RE: Huntsville WWTF Inspection

AFIN: 44-00018 Permit No.: AR0022004

OFFICE OF WATER QUALITY INSPECTION REPORT

Response to March 21st Compliance Evaluation

Office of Water Quality Photographic Evidence Sheet		
Location: Hu	Intsville WWTF		
Photographer	Garrett Grimes, District 1 Inspector Date: 03/21/2018	Time:	10:15
Witness:		Photo #	
Description:	Sludge dryer with tar dripping from the insulation onto the floor of the	e buildi	ng.

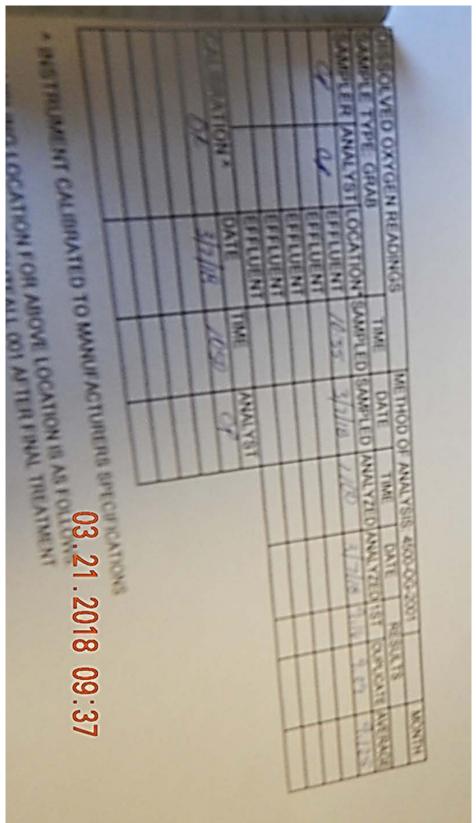
During the inspection some algae was observed growing in the clarifiers (Photo #2). Also, the sludge dryer appeared to be leaking tar from the insulation (Photo #3). The algae growing in the clarifier did not appear to be interfering with treatment, and Mr. Garrett and Mr. Eoff stated that the clarifiers are scrubbed. Mr. Eoff stated that the tar leaking from the sludge dryer was from insulation placed around the machine and would not contaminate the sludge. Even though the above concerns were not directly affecting treatment at the time of the inspection, the City of Huntsville should monitor and address these to avoid possible future operation and maintenance violations.

(photo #3) tar leaking from ducts on sludge dryer. We have scraped it up as best as possible and will continue to do so in the future as it leaks out.

photo #5 1

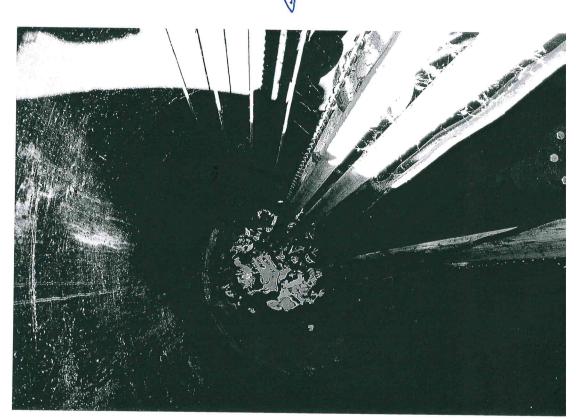
1. An open PVC pipe was observed located next to Cain St. lift station (photo #2). Mr. Garrett stated that he did not believe the pipe was installed into the sewer line.

Response: Pipe in question was excavated and found to lead to nothing. It was removed, top soiled, seeded, and covered in straw. (Refer to photo #5)
